Specific Site Assessment for Coal Combustion Waste Impoundments at Duke Energy Carolinas Lee Steam Station

Williamston, South Carolina

Submitted to:

LEE STEAM STATION - ASH BASIN
Secondary Dike @ STA 20+80

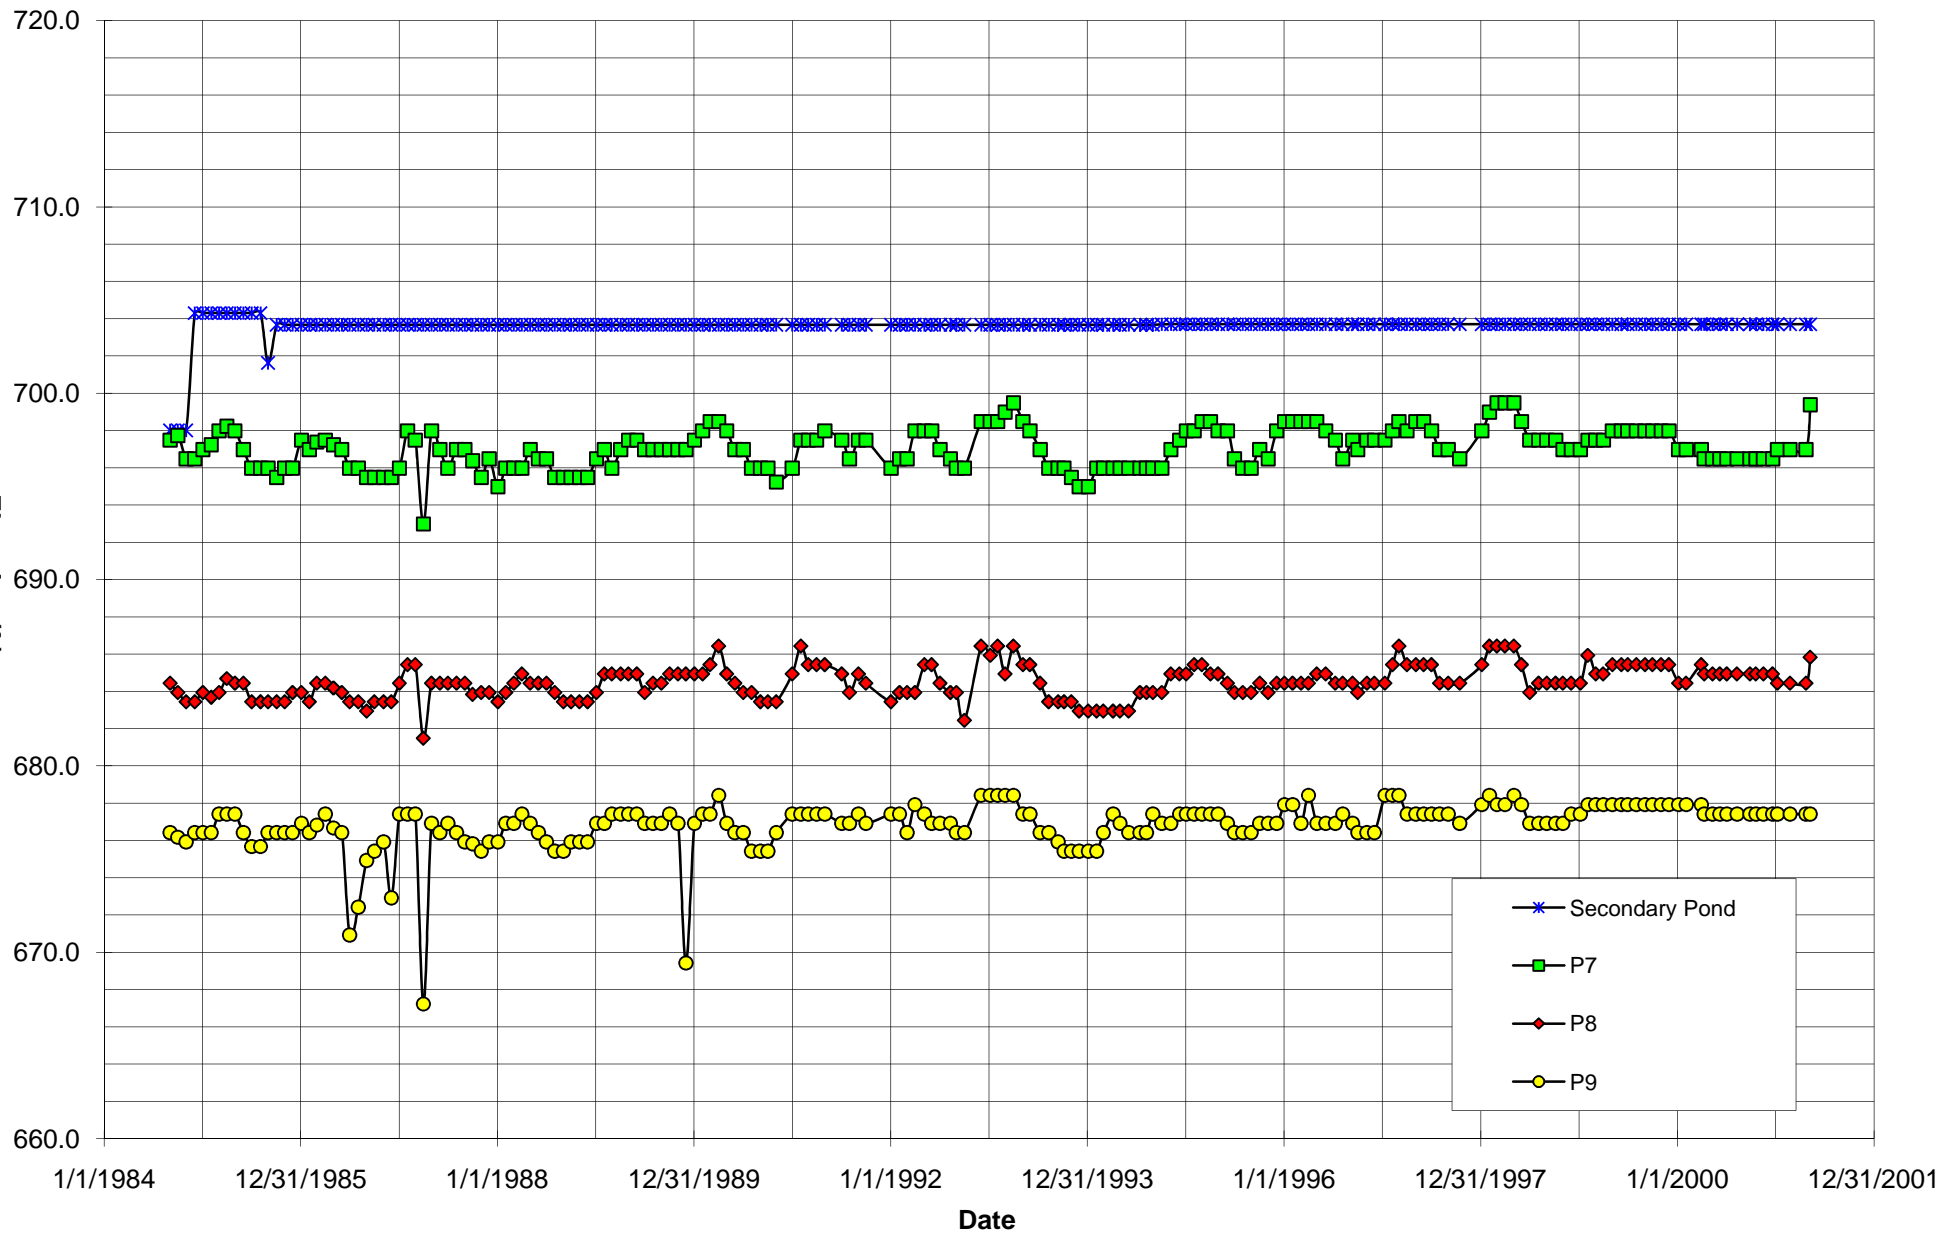
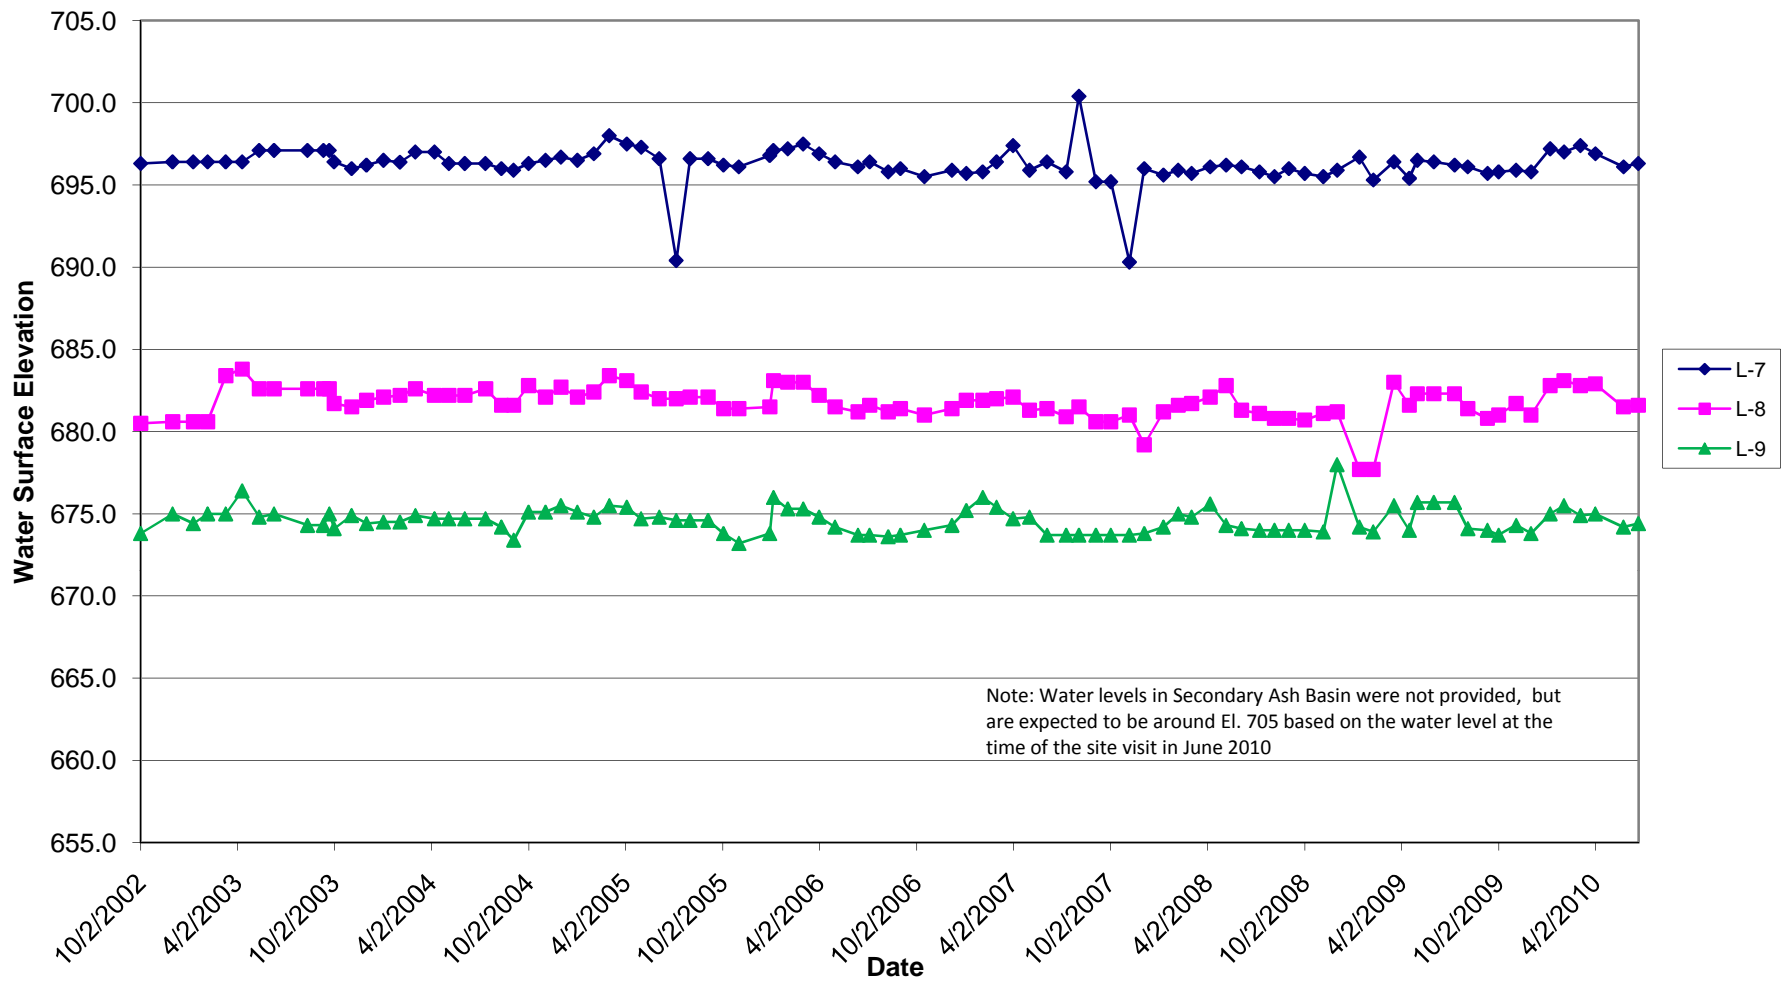
The water levels in piezometers L-7, L-8 and L-9, near the center of the Secondary Ash Basin dam, have remained relatively steady with time. These piezometers generally have fluctuated more than those in the other two cross sections. Typically the water levels in the piezometers fluctuate in parallel with one another and stay within about 5 feet of an average value with no steady increasing or decreasing trend. The water levels in L-7 and L-8 are similar to the water levels in the corresponding piezometers near the crest and mid-slope of the Primary Active Ash Pond dam. The water level in piezometer L-9, however, is about 10 feet higher than the water levels in the other two piezometers near the dam toe (El. 675 vs. El. 665). The toe drain at this location is located around El. 665 according to design drawings. This elevated water level may indicate that the toe drain is not functioning properly at this location. Piezometer L-9 is also located just west of the seepage area downstream of the right abutment of the Secondary Ash Basin dam, and the elevated water level may be related to the seepage observed at that location.

1. We recommend formal monitoring and analysis of the seepage area downstream of the right abutment of the Secondary Ash Basin in order to evaluate whether seepage could potentially compromise the stability of the dam. Monitoring should include installation of a weir and grading to direct seepage toward the weir. The weir should then be monitored monthly in order to establish a baseline measurement of seepage quantity. Continued monitoring will then show whether the seepage quantity changes with time. In addition, we recommend measuring turbidity in the seepage. A large amount of fines in the seepage could indicate piping of material through the dam.
